**MEETING AGENDA
SESSION OF THE PLANNING ADVISORY BOARD
CITY OF KISSIMMEE
CITY HALL, COMMISSION CHAMBERS
101 CHURCH STREET, KISSIMMEE, FLORIDA 34741-5054
WEDNESDAY, JANUARY 7, 2026 AT 6:00 PM**

5.A Public Hearing - CU-25-0017 — Conditional Use with Site Plan to establish an office at 1720 W Oak St.

DRC NUMBER: CU-25-0017

LS-01

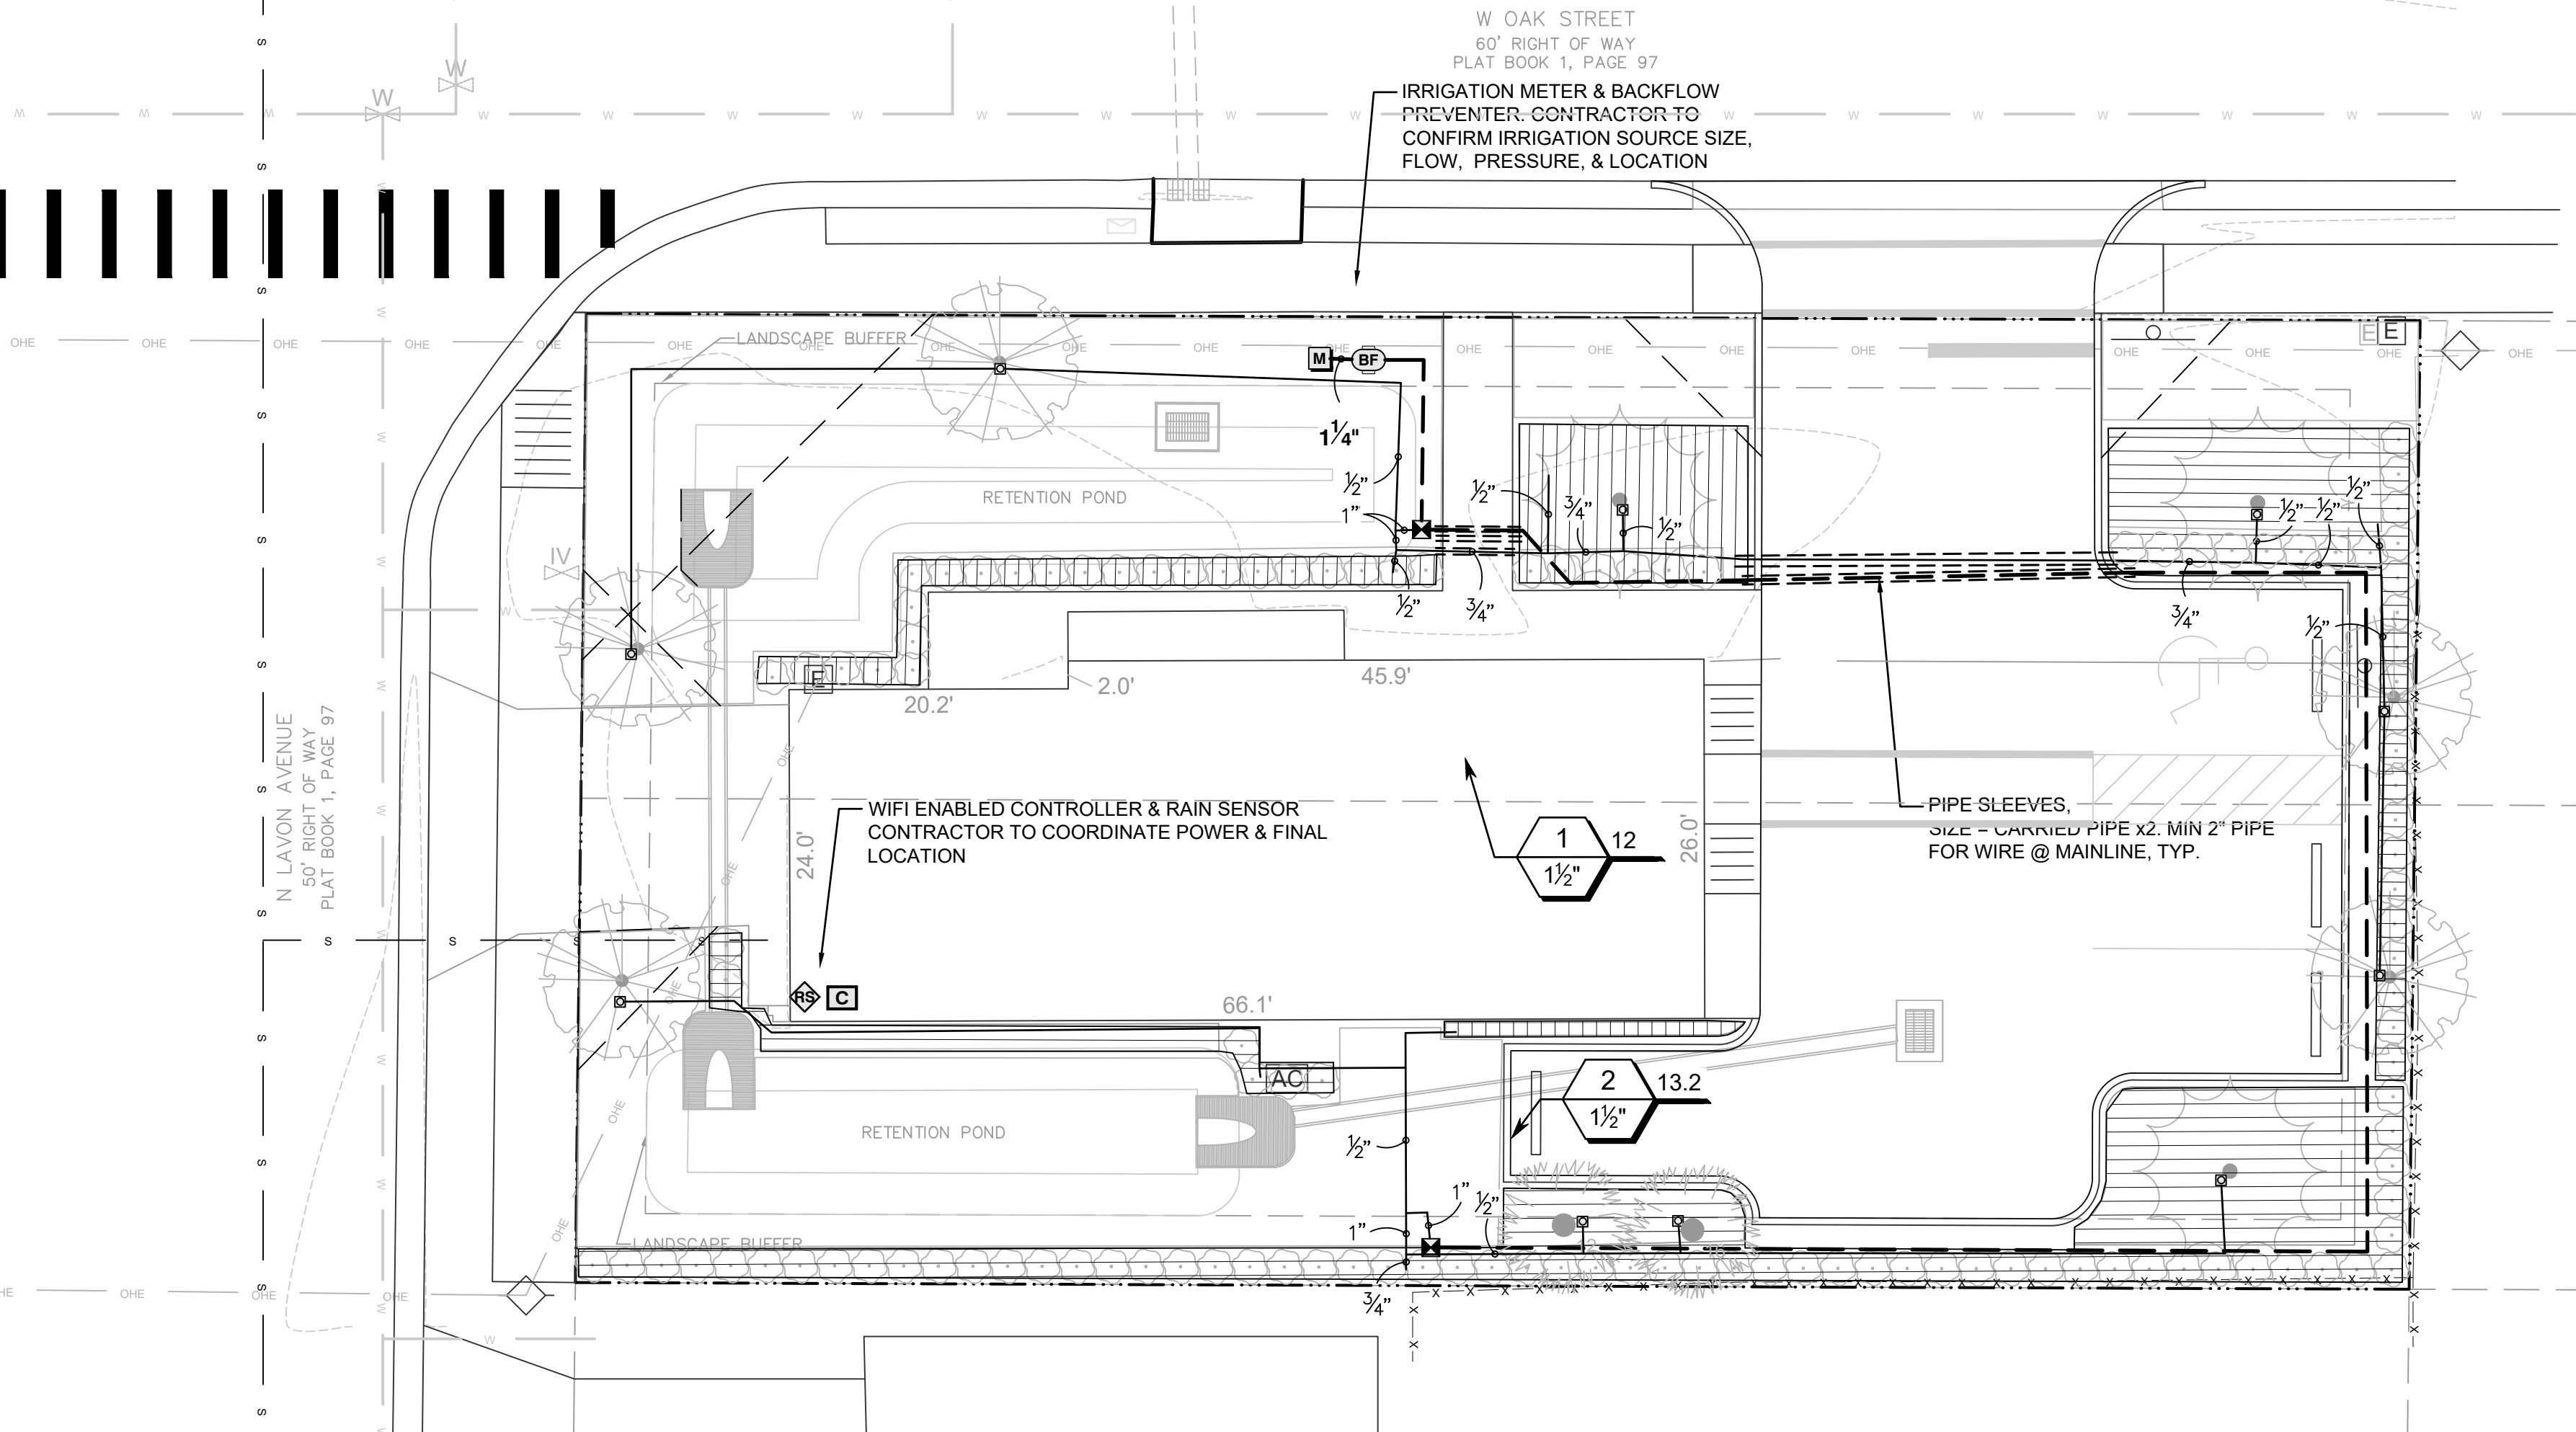
3. Show the 10-foot horizontal sight-distance triangles at driveway intersection(s) with the street on the landscaping plans, in accordance with LDC §14-7-2(B) and §14-2, Figure 2-10. Also show the 25-foot horizontal sight-distance triangles at the corner of intersecting streets.
4. Verify the following separation is provided between landscaping and site features, in accordance with §14-8-23, Table 8-1:
 - Sidewalks, curb/gutters, bikeways, driveways: 3 feet for understory trees, 5 feet for canopy trees
 - Intersections: 35 feet
 - Manholes/catch basins: 10 feet for understory trees, 10 feet for canopy trees
 - Street lights: 10 feet for understory trees, 25 feet for canopy trees
 - Regulatory signs: Not to block signs
